PLANNING NOTICE

APPLICANT:	Cohen & Associates Pty Ltd - PA\26\0045
PROPERTY ADDRESS:	43 & 49A Caveside Road MOLE CREEK (CTs: 77559/1, 77559/2, 77559/3, 131121/1)
DEVELOPMENT:	Subdivision (4 lots to 3 lots) - not connected to sewer & stormwater, attenuation area.

Land Use Planning and Approvals Act 1993 – Section 54 Request for Additional Information – 43 & 49A Caveside Road MOLE CREEK – Subdivision (4 lots to 3 lots)

Figure 2-1: 1% AEP (Climate Change) Flood Hazard Map

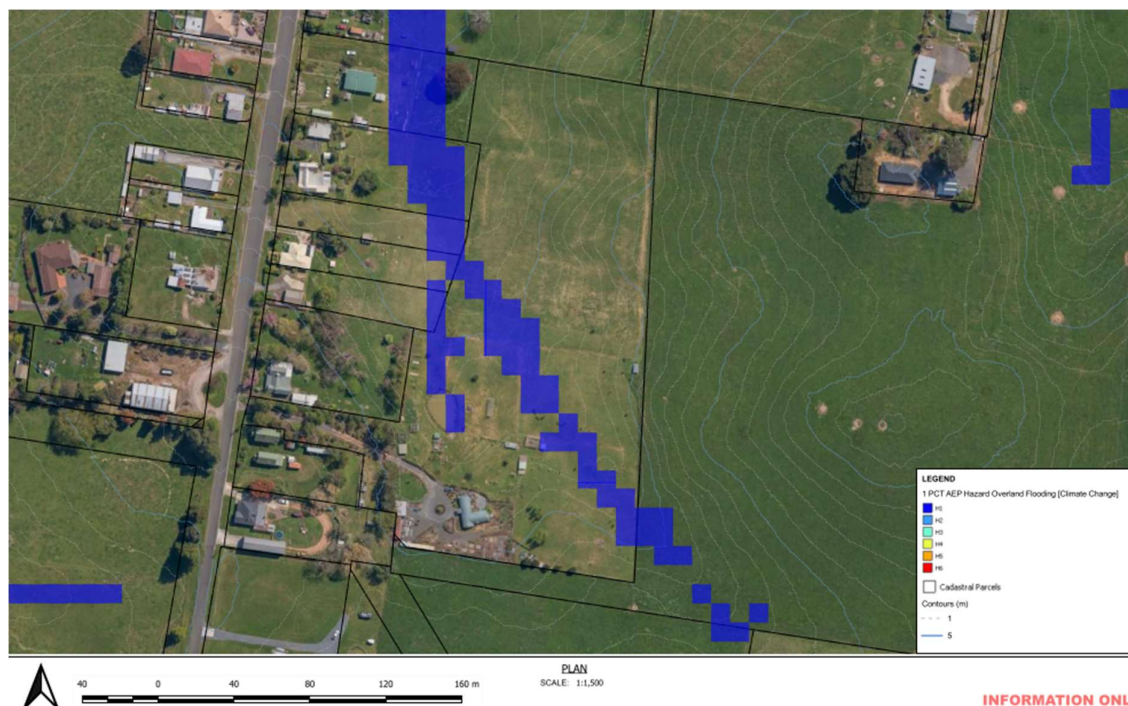
The report currently relies on the State Emergency Service (SES) flood mapping available through ListMap. As acknowledged in the methodology for that mapping, the mapping is based on a state-wide model intended to provide generalised results across the state. This approach introduces uncertainties when applied to regional scale flood modelling assessments and may not provide sufficient reliability for this site.

The response 3. d) II e), the ability to maintain access, notes access via the driveway will not be impacted. The SES modelling relied upon for the report shows the extent of flooding at the end of the access strip. Therefore it appears some form of access mitigation would be required for a future use and development on the lot. A similar concern is raised regarding the response to section 3.1, response to sub-clause d) of C12.7.1. Please address these concerns.

H1 hazard rating applies to flows below 0.3m in depth and less than 2.0m/s in velocity and is classed as generally safe for people, vehicles and buildings. Flood hazard ratings are outlined in the Australian Rainfall and Runoff (ARR) Guidelines. The combined flood hazard curves from the guidelines are shown in Figure 2-2.

Access to the dwellings will be via driveways which will see flows across them. Due to the low level of the hazard reported in the mapping, no specific controls are required. The design should have the access be largely in keeping with the current topography of the site to minimise disruption of flow paths and minimise any changes in flow behaviour.

Where IPD have used WMA Water’s mapping flow paths and hazard ratings the method adopted is suitable. In regard to the questions posed about reliability and suitability in the RAI, all modelling introduces uncertainty that is inherent in addressing 1% Annual Exceedance Probability (AEP) events and the reliability of the results for this site is good given that it is simply being used to identify flow paths and hazard ratings.

Figure 4-1: Potential Building Areas

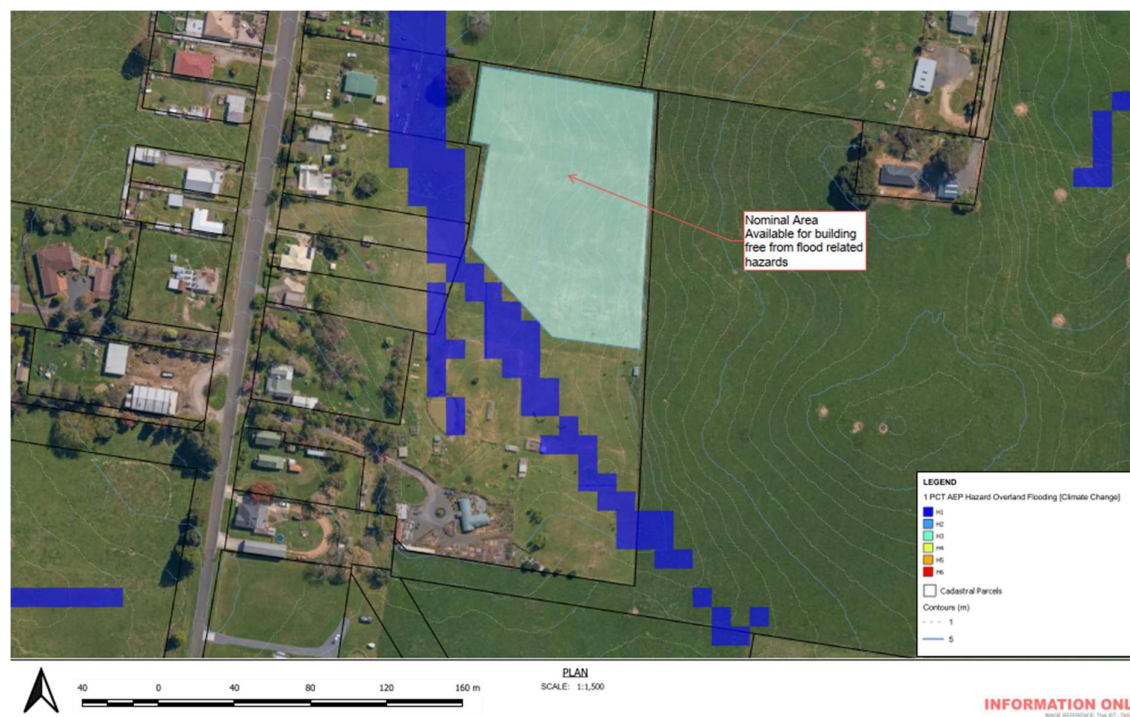
- The capacity for future use or development to adapt to changes in the level of risk over time, including the potential for change in the Hazard rating to a higher value such as H2.
- Any advice relating to the ongoing management of the site, use, or development in response to flood hazard.
- Conclusions and recommendations on measures to provide safe access to any future use and development on the proposed lots (for example, culvert sizing and location).

The infrastructure that is proposed for this subdivision is a new access off of Caveside Road. This access extends from the road to the property boundary. There is ample space within the proposed Lot 2 to site a house outside of the flow path as shown in Figure 4-1.

In addressing the performance criteria of Table 12.7.1 IPD have used their engineering judgment and the available statewide flood information to determine that there is a development option that can achieve tolerable risk, noting the mapped flood hazards are low (H1) and the buildings can be positioned outside of the flow paths. Notably, Table 12.7.1 of the planning scheme does not require the design or detailing of a solution, only that subdivision does not create an opportunity where a tolerable result is not possible. In this instance there exist many options, as Council have alluded to regarding culvert sizing, that can achieve a tolerable risk. Options such as a ford, installation of cut-off drains to direct flow around the driveway have been considered as possible options that would allow for development of the site with tolerable risk from flooding.
